SUMMARY OF CHANGES BETWEEN CONSENTED PLANNING DRAWINGS, AS PER APPLICATION REF 132952/JO/2022 AND PROPOSED SECTION 73 APPLICATION DRAWINGS:

Project Title
T2 VITA LIVING, ST. JOHNS

Drawing Title
PROPOSED EAST ELEVATION

Drawing Number
6555-P-B500-E-E

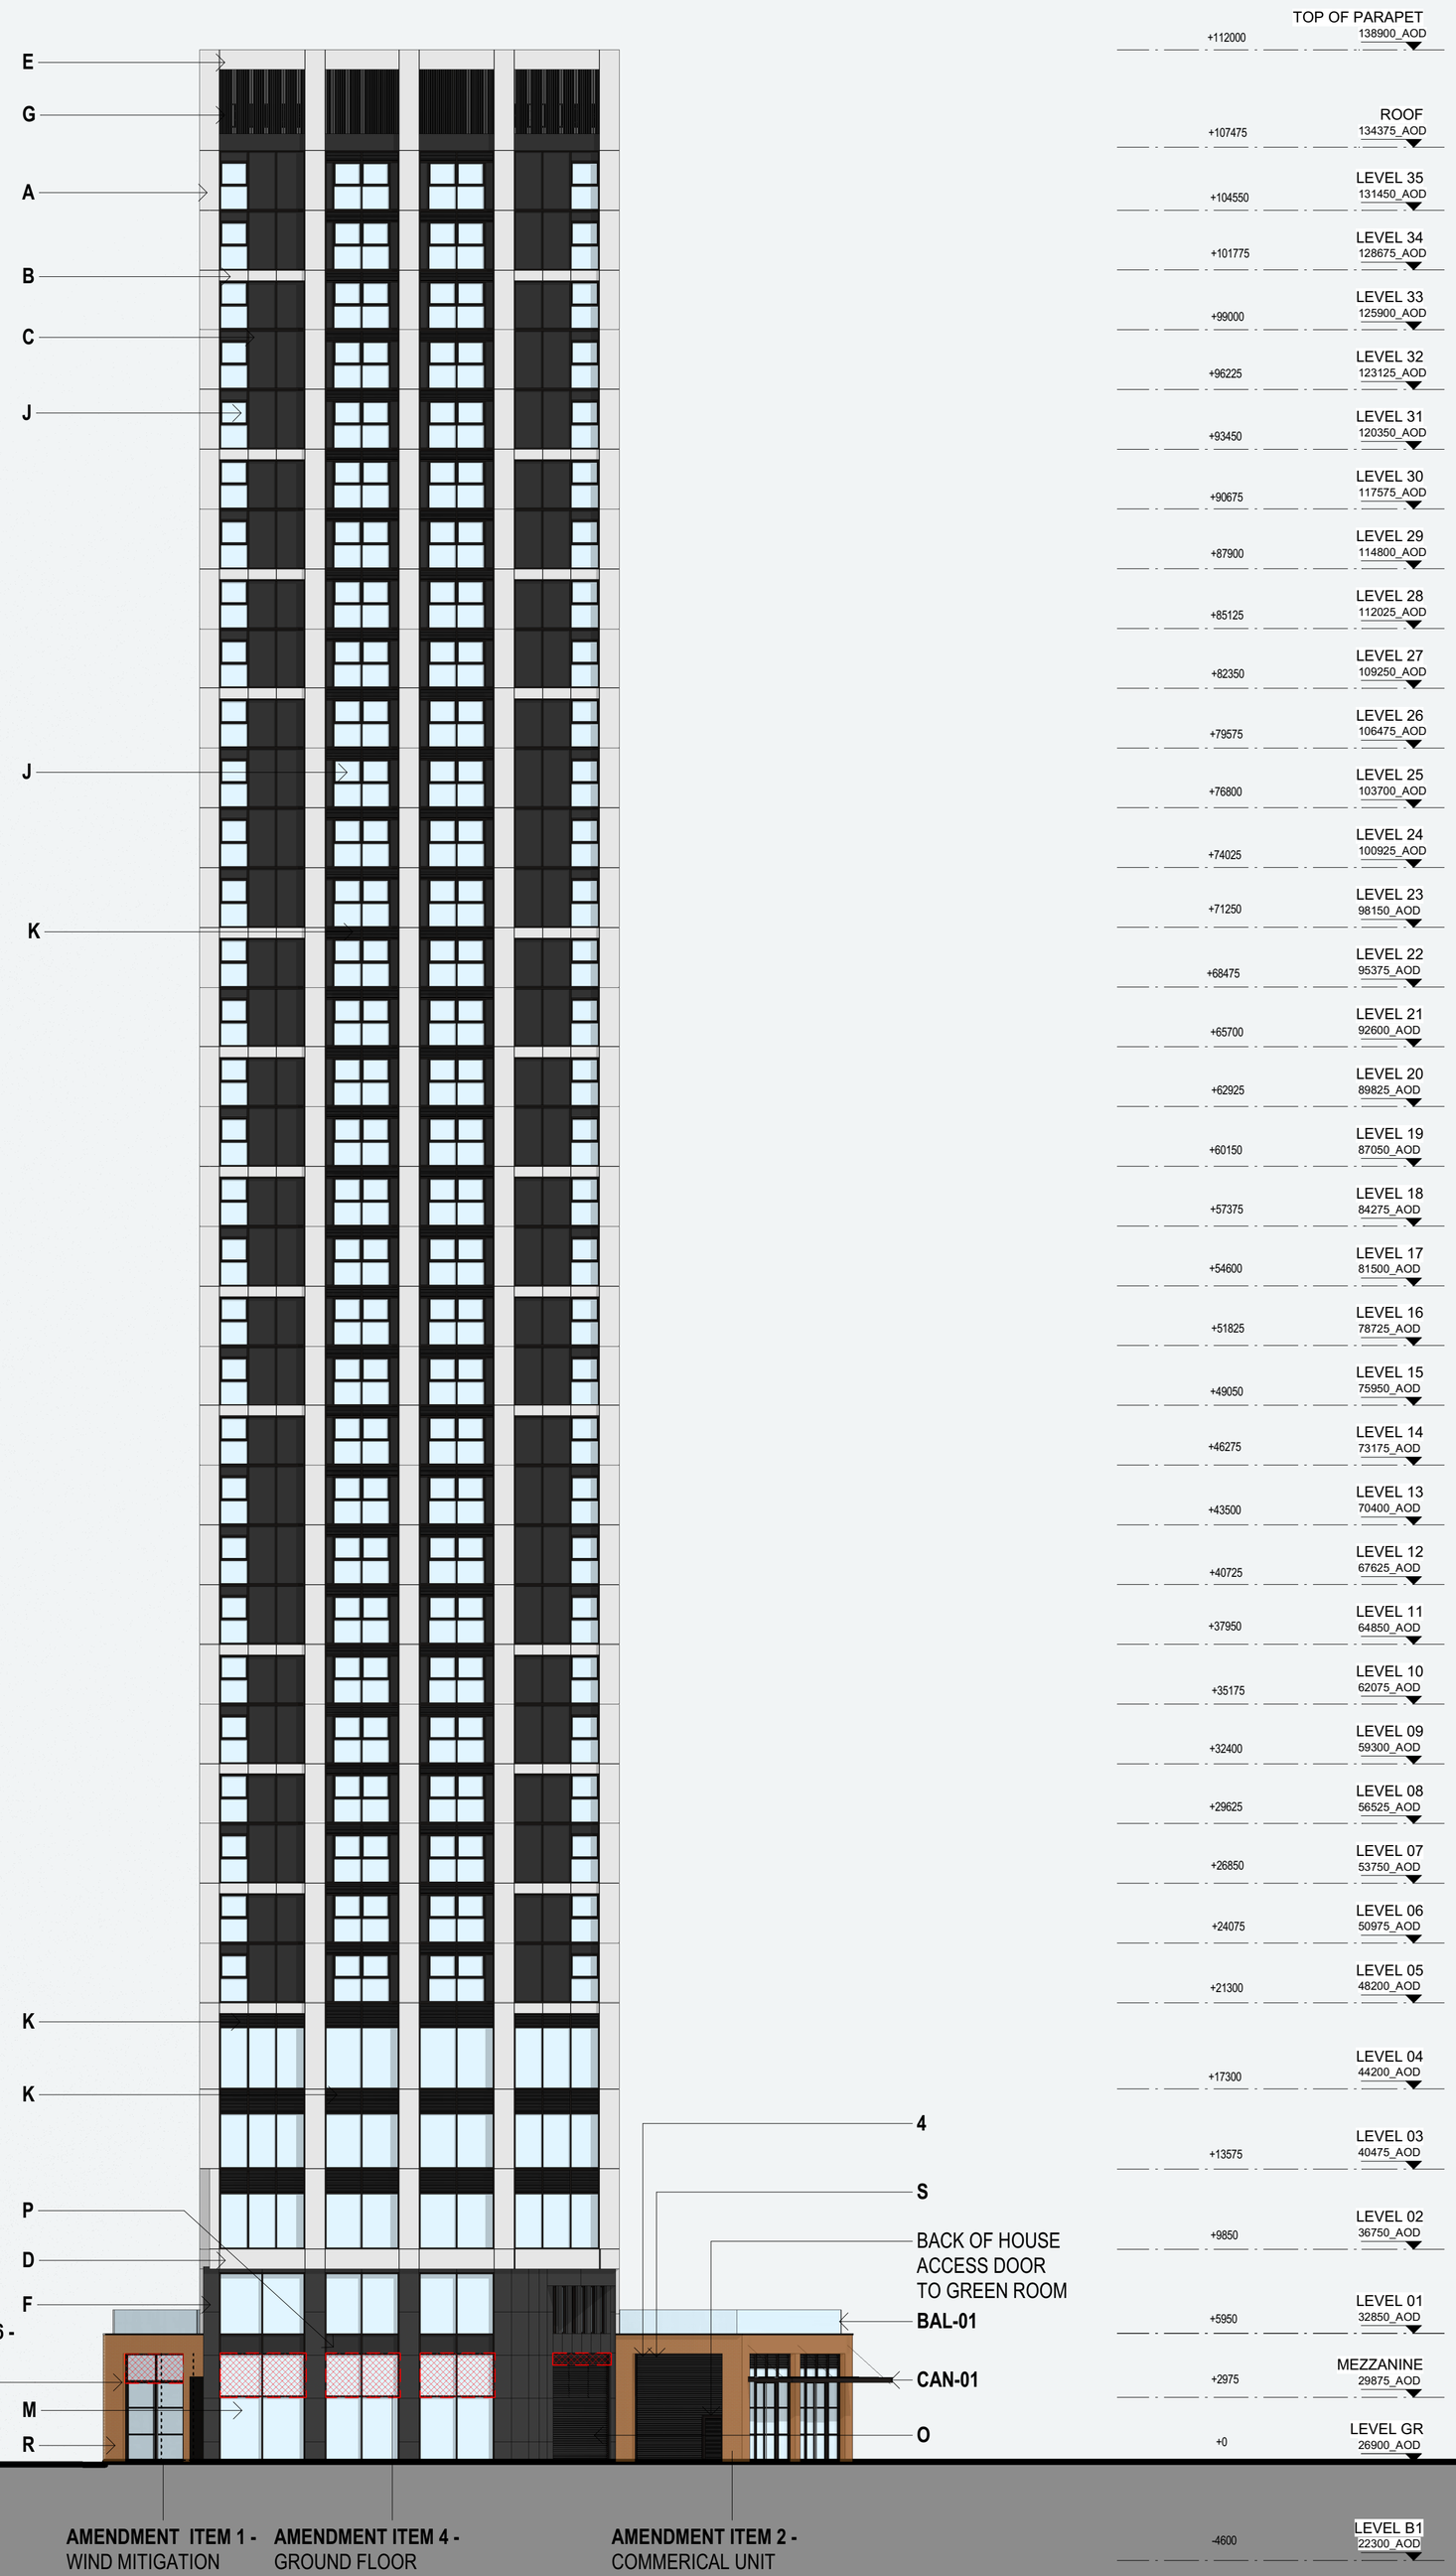
1 – WIND MITIGATION
WIND MITIGATION SCHEME AMENDED.

2 - COMMERCIAL UNIT BRICKWORK
EXTERIOR FACING BRICKWORK AMENDED FROM CERAMIC GREEN TO CLAY 'RED MULTI' MASONRY.

3 – LEVEL 01 EXTERNAL FACADE
FULL HEIGHT GLAZING PANELS SUBSTITUTED WITH LOUVRE PANEL TO SUIT INTERNAL LAYOUT

4 – GROUND FLOOR EXTERNAL FAÇADE
HEIGHT OF TRANSFORM TO GROUND FLOOR CURTAIN WALLING DROPPED BY C.400MM

5 – MAIN ENTRANCE 'PORTAL' DOOR
OUTER SLIDING DOOR ALIGNED WITH MAIN FACADE LINE. GLAZING AROUND DOOR SUBSTITUTED WITH PERFORATED DECORATIVE PANELS TO INCORPORATE INTERNAL NATURAL VENTILATION RISER. GLAZED PANEL TO OUTER AND INNER DOOR AMENDED TO ALIGN WITH CONSENTED DESIGN FOR T1 (REF.136508/NMC/2023).

6 – COMMERCIAL UNIT EXTERNAL DOORS
POSITION OF COMMERCIAL UNIT MAIN ENTRANCE DOOR AMENDED. SIZE AND SWING OF EXTERNAL DOORS TO NORTH ELEVATION OF COMMERCIAL UNIT AMENDED.

7 - COMMERCIAL UNIT FACADE GLAZING
EXTENT OF LOUVRES IN CURTAIN WALLING TO COMMERCIAL UNIT RATIONALISED. FULL HEIGHT GLAZING TO WEST ELEVATION
